SYDNEY CENTRAL PLANNING PANEL

SCPP No	2016SYE089
DA Number	16/143
Local Government Area	Bayside Council
Proposed Development	Stage 2 Integrated Development Application for the construction of a residential flat building consisting of one level of basement car parking, a 3 storey podium including car parking sleeved with apartments, and 2 x 6 storey, 1 x 8 storey and 1 x 16 storey towers above
Street Address	130-150 Bunnerong Road, Pagewood NSW 2035
Applicant	Karimbla Constructions Services (NSW) Pty Ltd
No. of Submissions	Nine (9) submissions; one petition with 36 signatures
Regional Development Criteria	Development with a CIV of \$69,616,383
List of All Relevant s79C(1)(a) Matters	<ul style="list-style-type: none"> • Environmental Planning & Assessment Act 1979, Part 4 – Development Assessment & Schedule 4A – Development for which regional panels may be authorised to exercise consent authority functions of councils • Environmental Planning & Assessment Regulation 2000, Part 6 – Procedures relating to Development Applications • State Environmental Planning Policy (Infrastructure) 2007 • State Environmental Planning Policy No. 55 – Contaminated Land • State Environmental Planning P

Figure 22: Proposed Internal Building Separation between Towers B and C

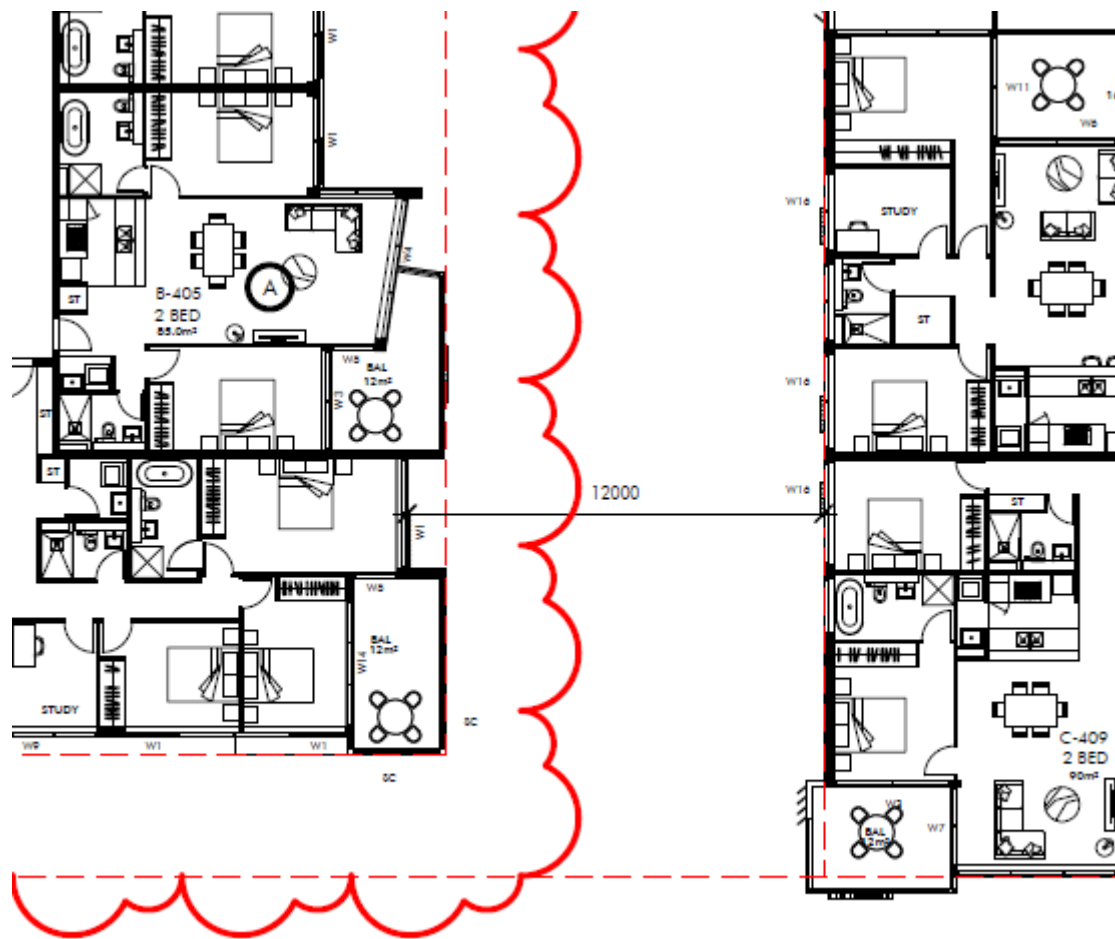
The Stage 1 consent approved a separation distance of 12 metres between Tower A and Tower B, 12.4 metres between Tower B and Tower C and 20 metres between Tower A and Tower D. The proposed development is generally consistent with the approved building separation distances. However, the proposal does not comply with the building separation between Tower B and Tower C (rear towers). The required separation distance is 12.4 metres while the development proposes a separation of 12 metres. The non-compliance is a variance of 400mm and is contained to a small portion of the building between a bedroom within B-504 and C-409 (and each respective level above in both towers). Figure 22 below demonstrates the non-compliance:

It is noted that the non-compliance is only contained in one small area of the building and measures an additional 400mm within both bedrooms. Council requested that the applicant provide a privacy treatment plan to demonstrate what measures are in place to mitigate any overlooking between the two towers. Sliding screens are proposed over the floor to ceiling windows to reduce the impact between the two units and redirect view lines from the bedrooms. This is demonstrated in the privacy plan in Figure 23 below.

Although the site does not comply with the Stage 1 consent, the non-compliance allows for greater amenity within these bedrooms and greater circulation spaces within the area. Therefore, for the justification provided above, the minor non-compliance in this case is acceptable as it is limited to a small portion of the building and privacy measures have been proposed to mitigate any adverse visual privacy concerns.

Figure 24: Building Articulation Plan

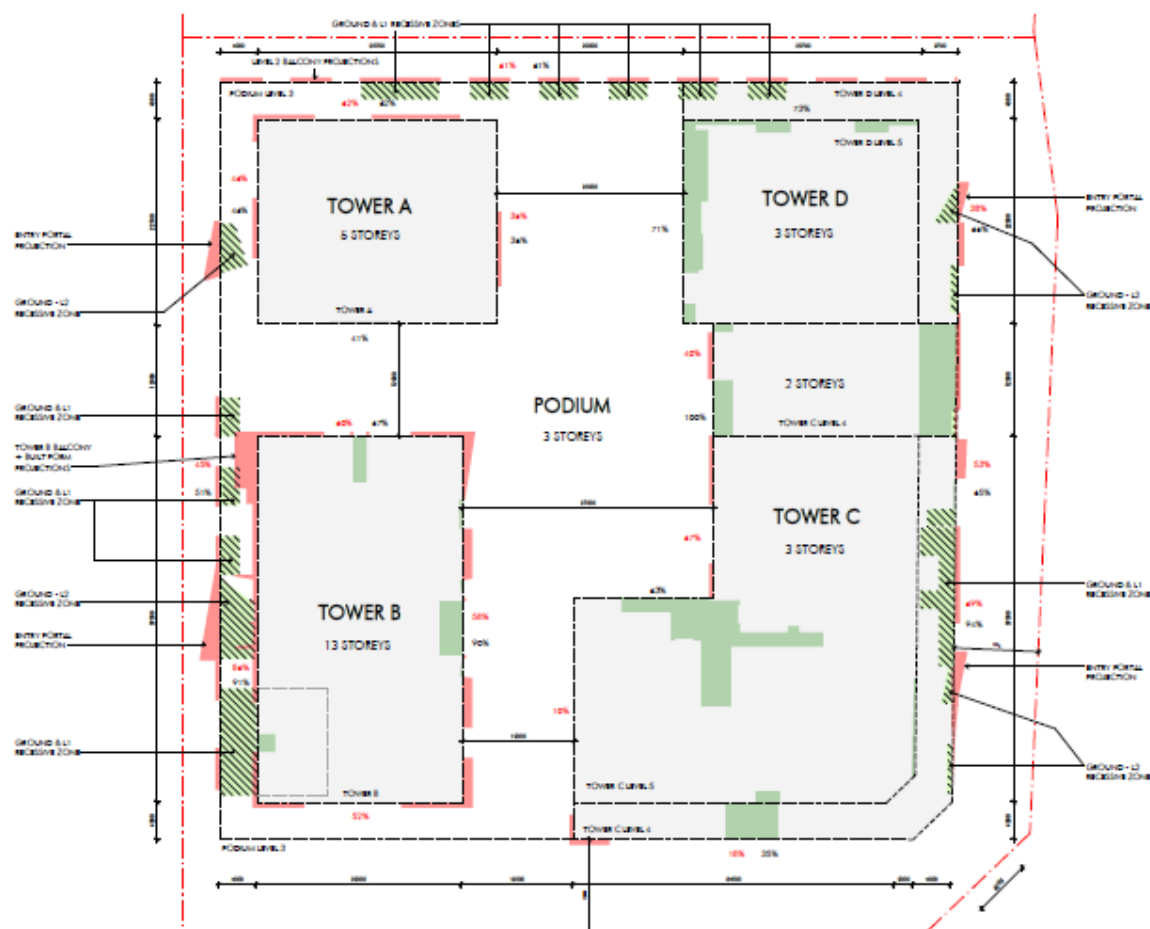
The applicant has provided a building articulation plan (Figure 24) to demonstrate the areas of protrusion and recessive zones. The areas highlighted in red are the protrusion zones and the areas highlighted in green are the proposed recessive zones for both the towers and the podium. As demonstrated in the plan, the areas of recession are greater than the areas of protrusion. It is clear that Tower B proposes greater articulation on each façade which is contributed to the balconies extending over the setback envelope approved in Stage 1.

The proposal meets the objective of the conditions to provide articulation and the meaning of 'façade' in the condition could be interpreted as meaning the combination of the 4 faces of each tower. Using this meaning for 'façade' the proposal achieve the maximum 50% articulation outside the approved envelope for the entire site. This is acceptable in this case.

Figure 25: Northern Elevation of the proposal (left) and the winning scheme (right)

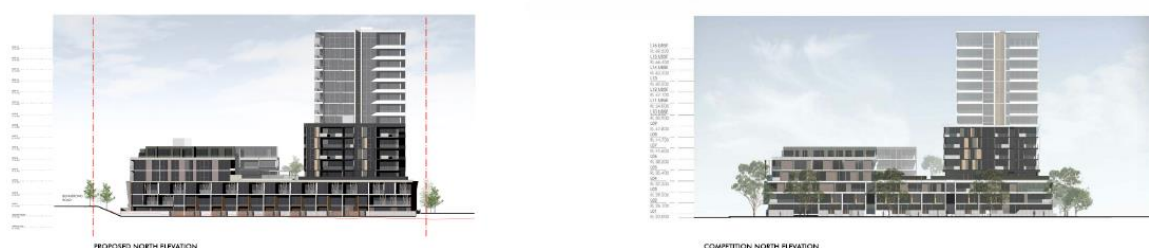
- Building cut/indentation on northern façade – The building cut/indentation on northern façade of the main tower (Building B) has been completely removed. This is a significant architectural feature of the winning design and provides a visually interesting element that breaks up this large façade. The indentation is to be reinstated in its original form (Figure 1);

- Building cut/indentation on the northern façade deleted;
- Building cut/indentation on the western façade deleted;
- Ground Floor apartments replaced 2 storey town house apartments;
- Materials on the main tower and podium were removed and modified;
- Materials along the Bunnerong Road street wall were removed.

Amended plans were provided on 9 November 2016 and 4 January 2017 demonstrating that the amended proposal has reverted back to the winning design. As the amended design is generally consistent with the winning scheme from the competition, Council has not obtained advice from a Design Review Panel for this application.

Figure 26: Western Elevation of the proposal (left) and the winning scheme (right)

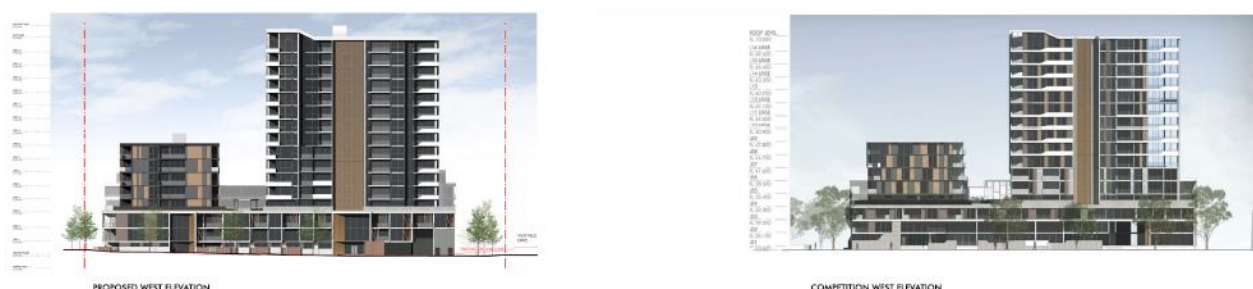
- Building cut/indentation on western façade – The building cut/indentation on western façade of the main tower (Building B) has been reduced in depth and materials changed from soft timber elements to hard metal elements. The proposed indentation is not considered deep enough, and the materials too similar to the building, to appropriately break up the façade and provide visual interest. The indentation in its original form is to be reinstated (Figure 1);

Figure 28: Proposed Section of floor to floor heights

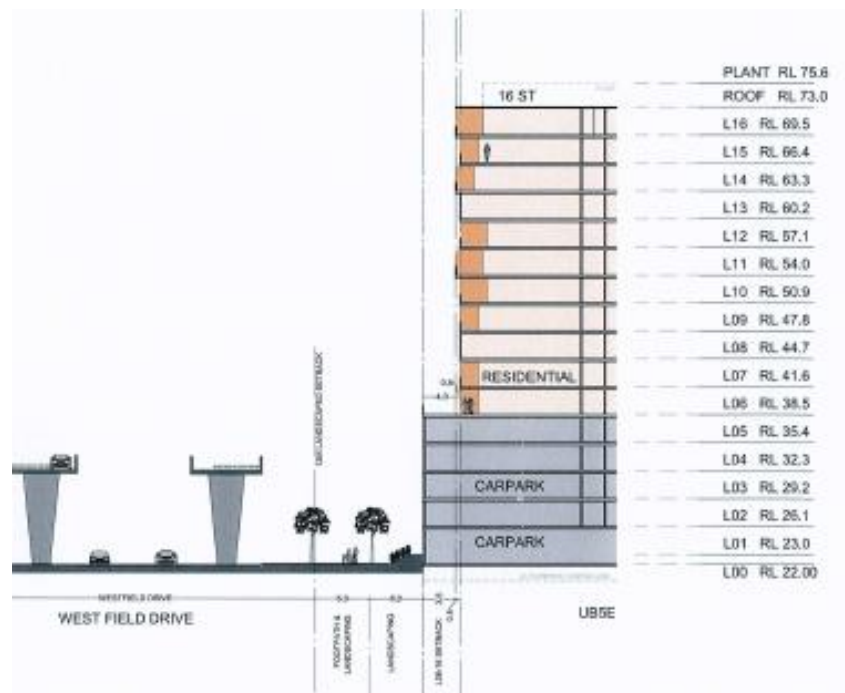
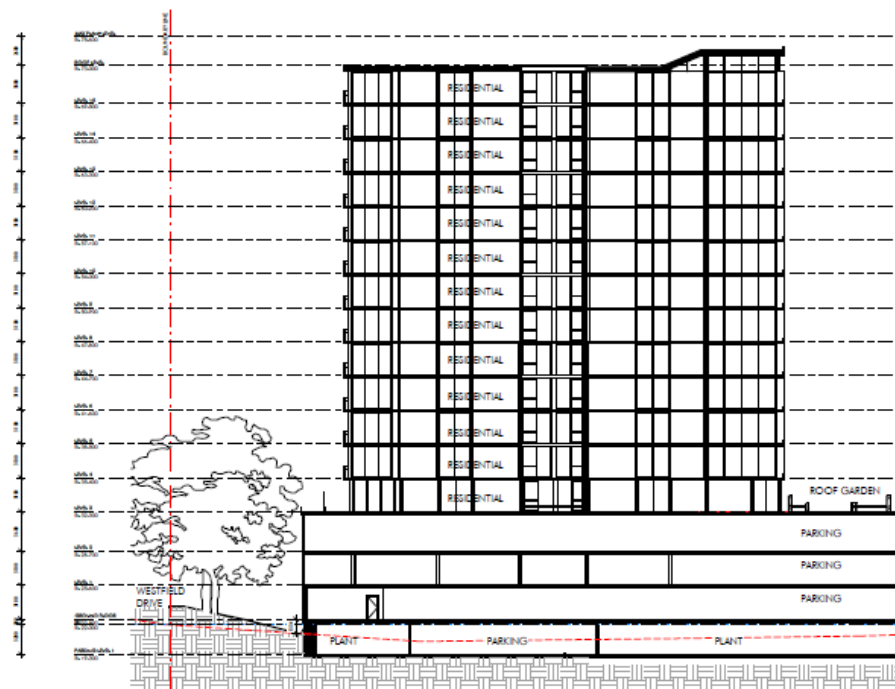
Similar to what was approved at Urban Block 5W, the ground and first floor apartments of the development provide a floor to ceiling height of 2.7 metres. The Stage 1 consent approved plans includes Section drawing (Section H-H) of UB5E which demonstrate a 3.1 metre floor to floor distance for both the ground and first floor levels. This equates to approximately 2.7 metres floor to ceiling height which the current proposal provides. The Stage 1 consent establishes the prescribed height for the site and the developments. Given that compliance with the minimum ceiling height control would increase the height limit approved in Stage 1, it is not possible to provide increased ceiling heights to the ground and first floor.

It is key to note that the Stage 1 consent has only approved retail in UB5C up to a maximum of 5,000sqm. The subject site did not approve any retail within the building envelope and the development is wholly residential. Therefore it is not anticipated that the ground and first floor of the development will be converted to retail. Given the above justification, the proposed non-compliant ceiling heights are acceptable.

Figure 30: Apartment C-407 with no window in study, similar in C-307 and C-507

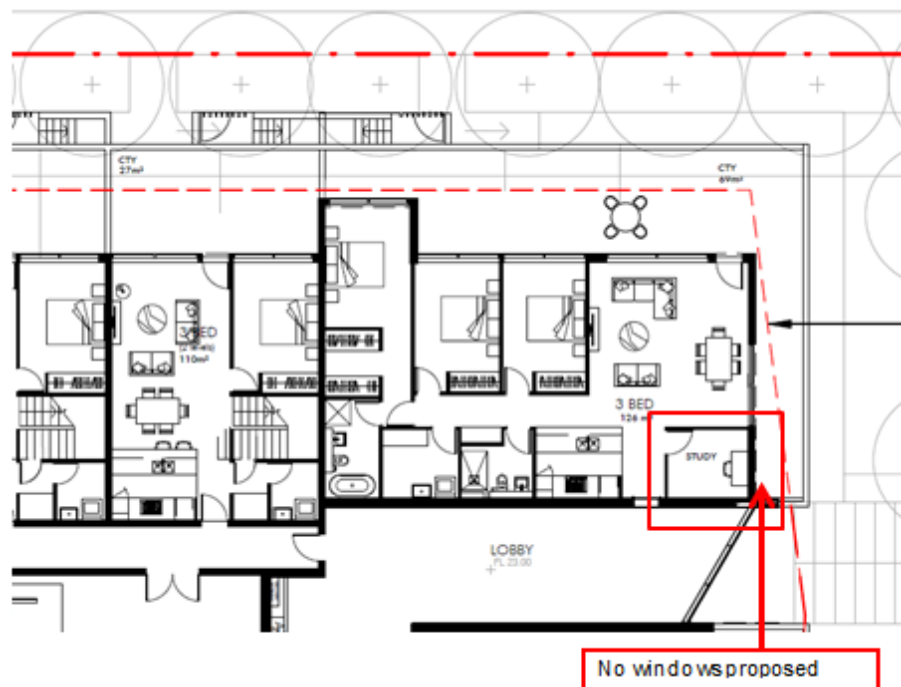
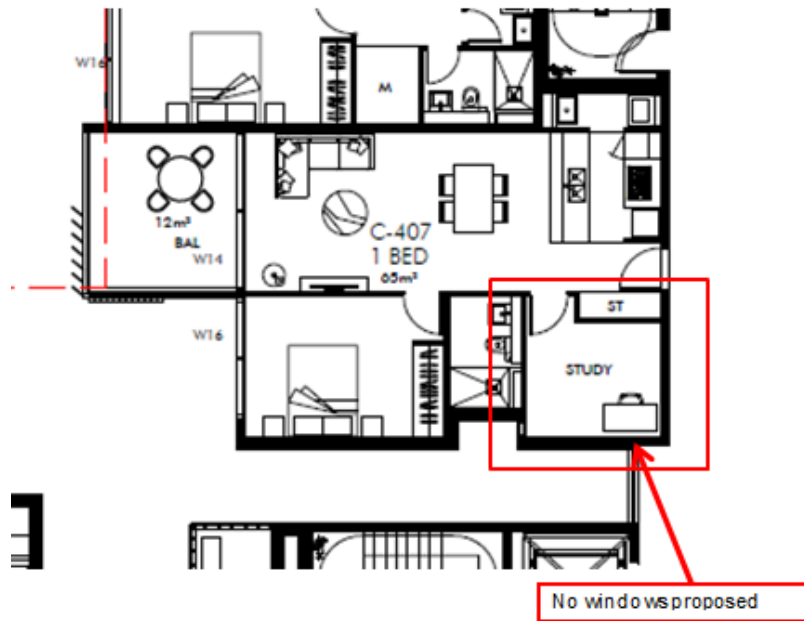
Part 4D – Apartment size and layout of the ADG requires every habitable room to have a window in an external wall with a total minimum glass area of not less than 10% of the floor area of the room. The proposal is generally consistent in this control however four of the apartments contain separate study rooms that do not contain windows. The non-compliances are located in the north-eastern ground floor apartment and within Apartment C-307, C-407 and C-507. The below figures demonstrate the non-compliance to this design criteria. Given that the non-compliance is quite minor and the external wall could accommodate windows within each of the rooms, a condition has been recommended to provide at least one window with a size at least 10% of the floor area of the room, to satisfy this requirement.
